POLK COUNTY, A POLITICAL SUBDIVISION OF THE STATE OF FLORIDA ADDENDUM # 3

BID 26-217, COUNTRY CLUB ROAD AT BUCKEYE LOOP ROAD INTERSECTION IMPROVEMENTS

**Bid 26-217, Country Club Road at Buckeye Loop Road Intersection Improvements
Addendum # 3**

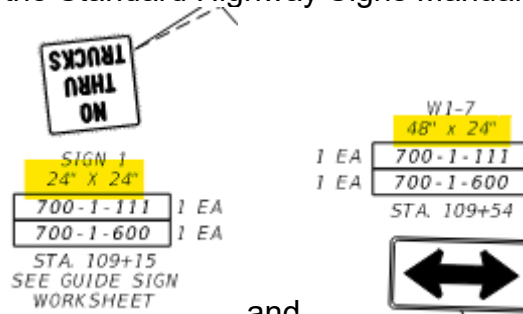
Q2: Can the County provide LF of striping highlighted in yellow?

A2: Per the FDOT Basis Of Estimates (BOE) manual these pay items are measured in Gross Mile. Gross Mile can be converted to LF by multiplying the number of gross miles by 5,280.
